TRANS/WP.29/725

World Forum for Harmonization of Vehicle Regulations (WP.29)

DRAFT SUPPLEMENT 2 TO THE 01 SERIES OF AMENDMENTS TO REGULATION No. 52

(Small capacity public service vehicles)

"5.7.4. Access to escape hatches

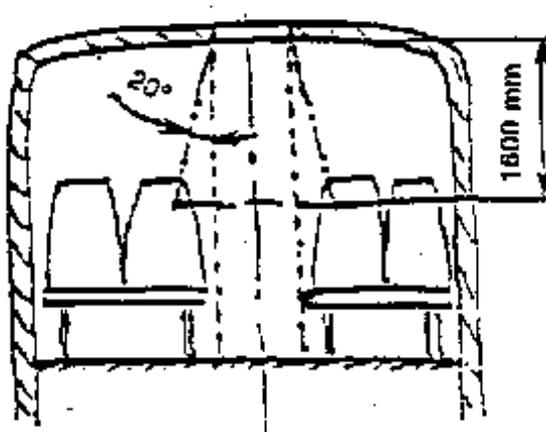
5.7.4.1. If an escape hatch is fitted in a Class B vehicle, at least one escape hatch shall be located such that a four-sided truncated pyramid having a side angle of 20° and a height of 1,600 mm touches part of a seat or equivalent support. The axis of the pyramid shall be vertical and its smaller section shall contact the aperture area of the escape hatch. Supports may be foldable or movable provided they can be locked in their position of use. This position shall be taken for verification.

5.7.4.2. When the structural thickness of the roof is more than 150 mm, the smaller section of the pyramid shall contact the aperture area of the escape hatch at the level of the outside surface of the roof."
